[Docket No. FAA-2007-28661; Directorate Identifier 2007-NM-013-AD; Amendment 39-16785; AD 2011-18-03]

Airworthiness Directives; The Boeing Company Model 737-600, -700, -700C, -800, and -900 Series Airplanes

ACTION: Final rule.

Figure 1

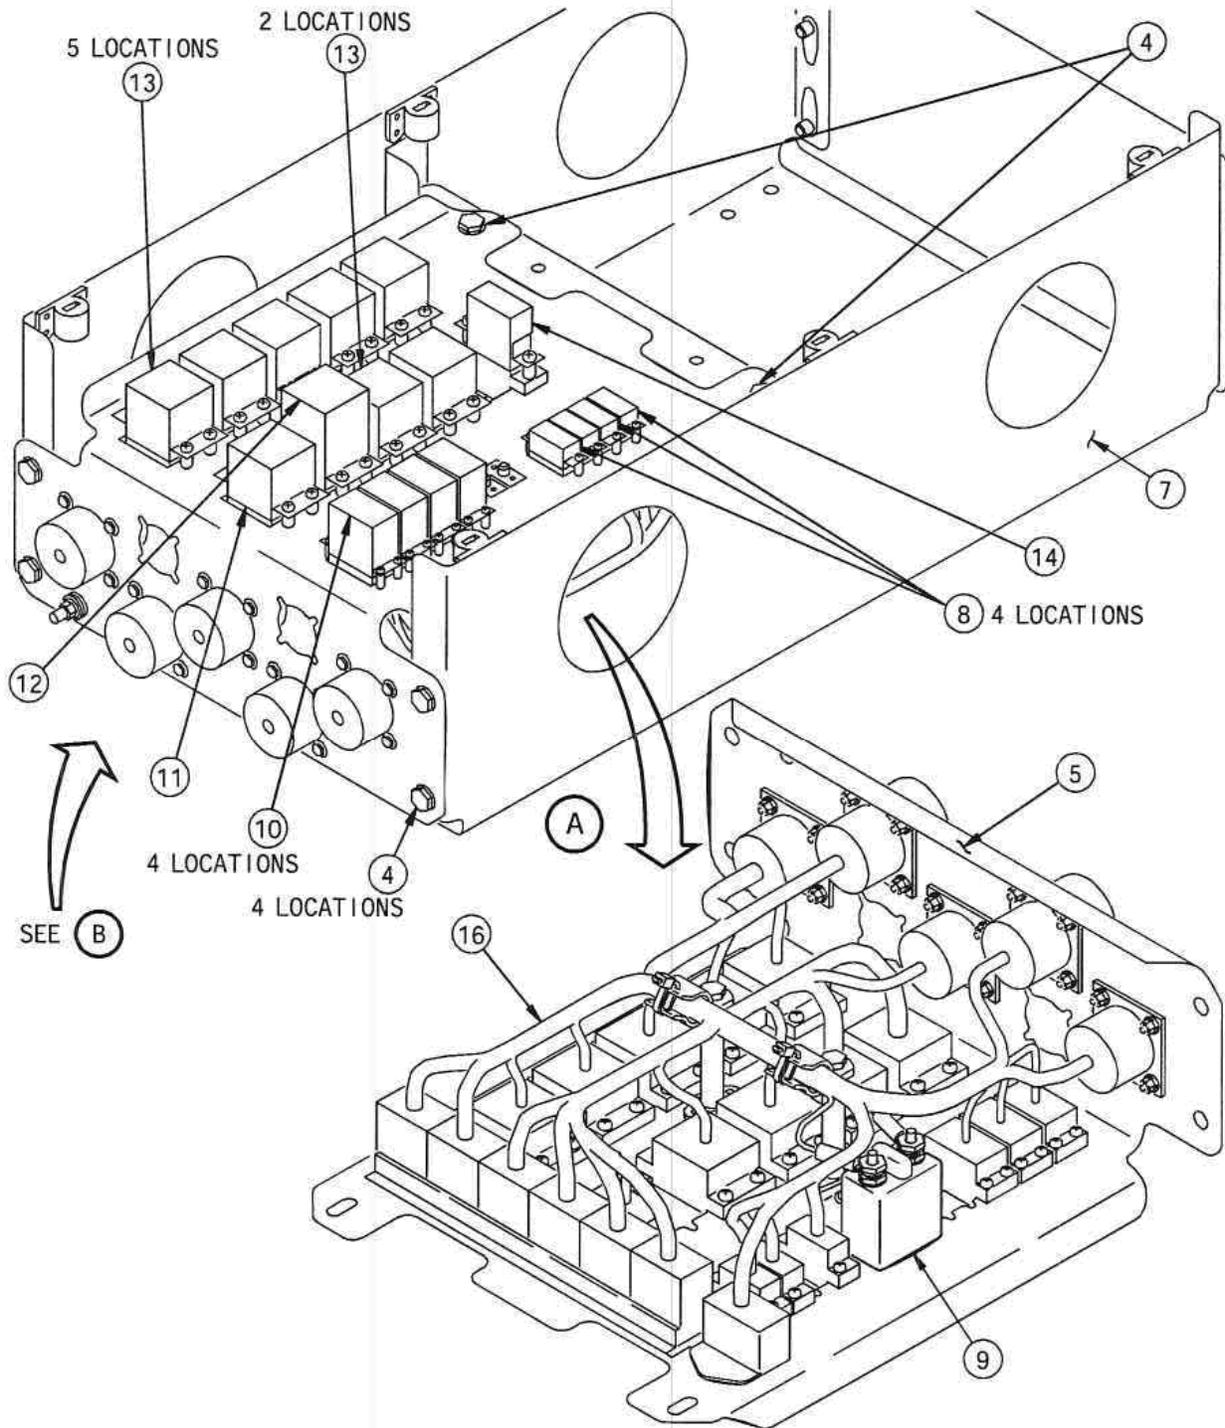
(g) For airplanes identified in paragraph 1.A.1. of Boeing Alert Service Bulletin 737-28A1206, Revision 2, dated May 21, 2009: Within 36 months after the effective date of this AD, install an automatic shutoff system for the center tank fuel boost pumps, by accomplishing all of the actions specified in Part 1 and Part 2 of the Accomplishment Instructions of Boeing Alert Service Bulletin 737-28A1206, Revision 2, dated May 21, 2009, except that Figure 1 of this AD must be used in lieu of Sheet 2 of Figure 11 of Boeing Alert Service Bulletin 737-28A1206, Revision 2, dated May 21, 2009. If a placard has been previously installed on the airplane in accordance with paragraph (h) of this AD, the placard may be removed from the flight deck of only that airplane after the automatic shutoff system has been installed. Installing automatic shutoff systems on all airplanes in an operator's fleet, in accordance with this paragraph, terminates the placard installation required by paragraph (h) of this AD for all airplanes in an operator's fleet.
